# BULLETIN # 0 2

**PROJECT:** Harrison Recreation & Community Center – PHASE 1  
Harrison, NY

**RE:** Revised foundation wall at Column Line A

Sheet Title  
**REVISED BRICK SHELF COLUMN LINE A**

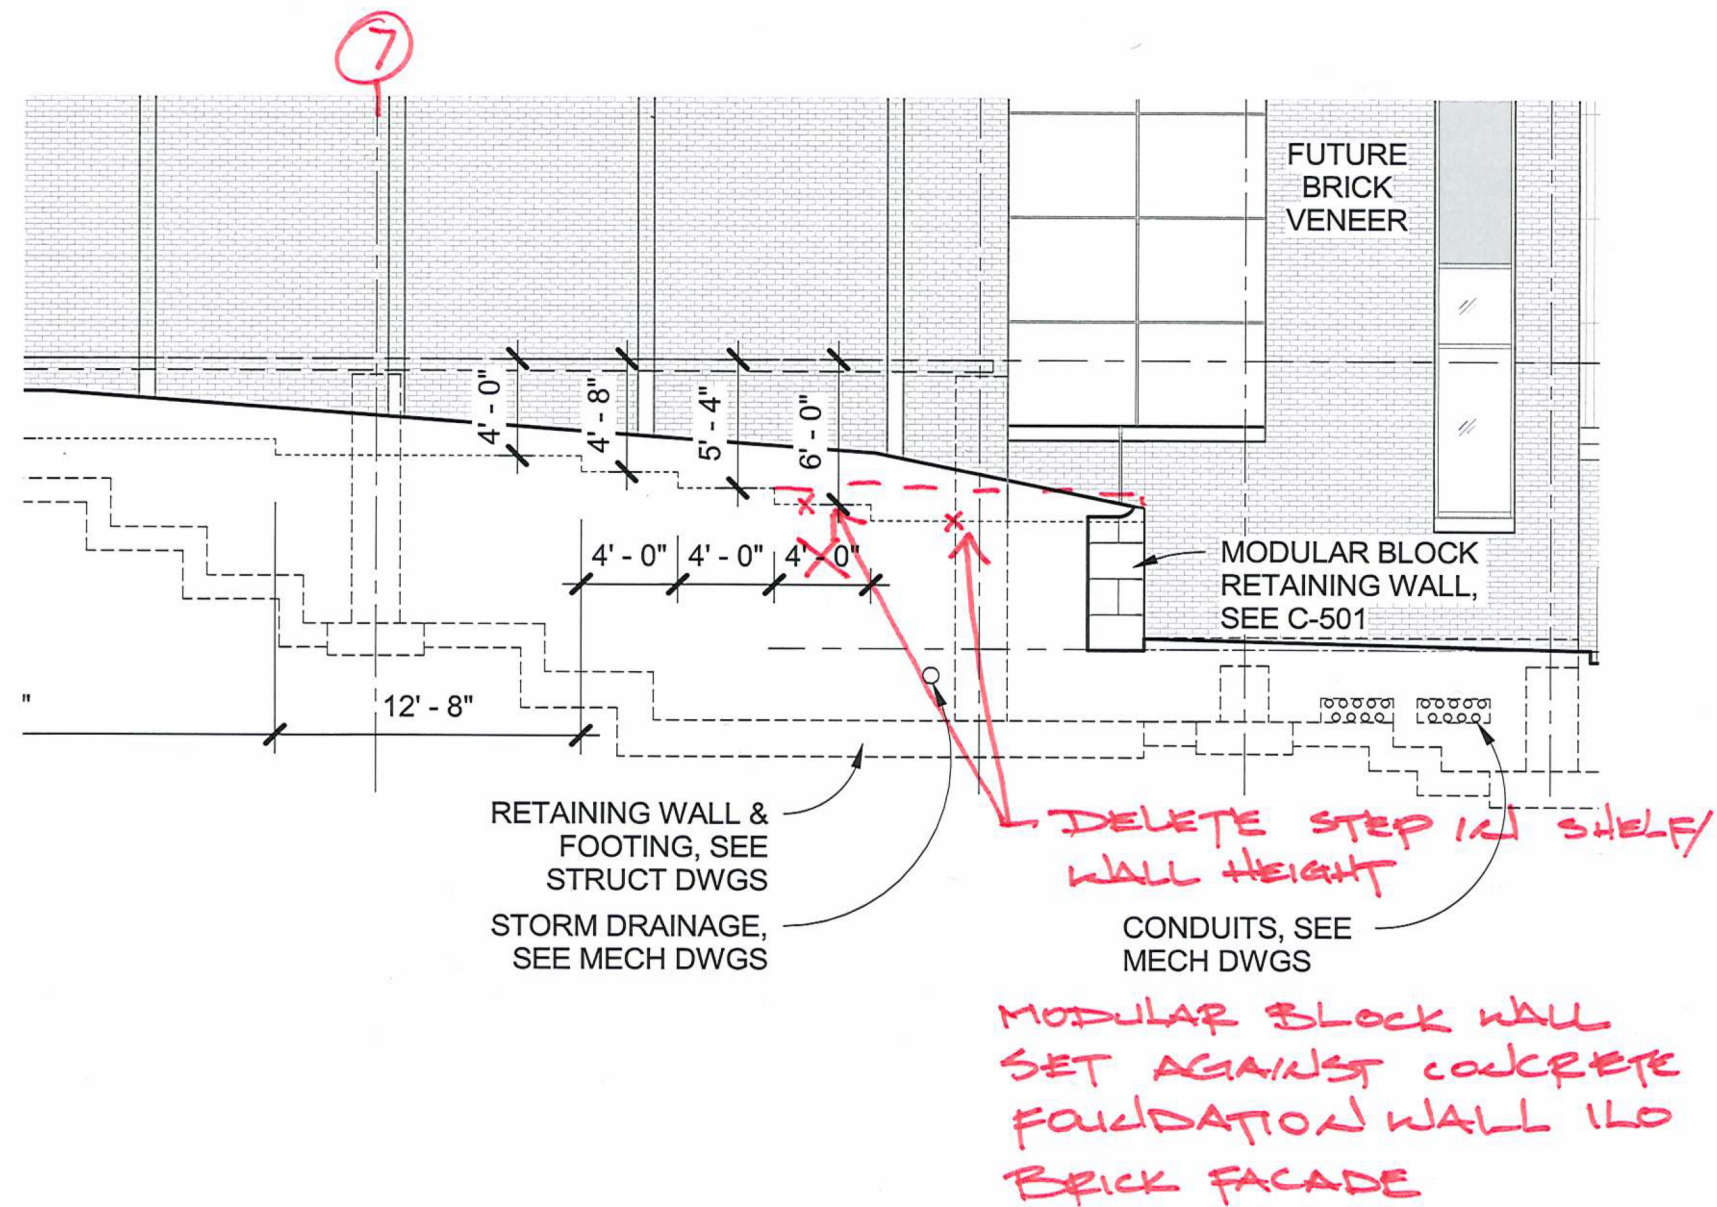
Per the attached ASK-02 revise the brick shelf at Column Line A so that the modular block wall will abut the concrete foundation wall ILO the brick façade. Delete the steps in the brick shelf as shown on the sketch.
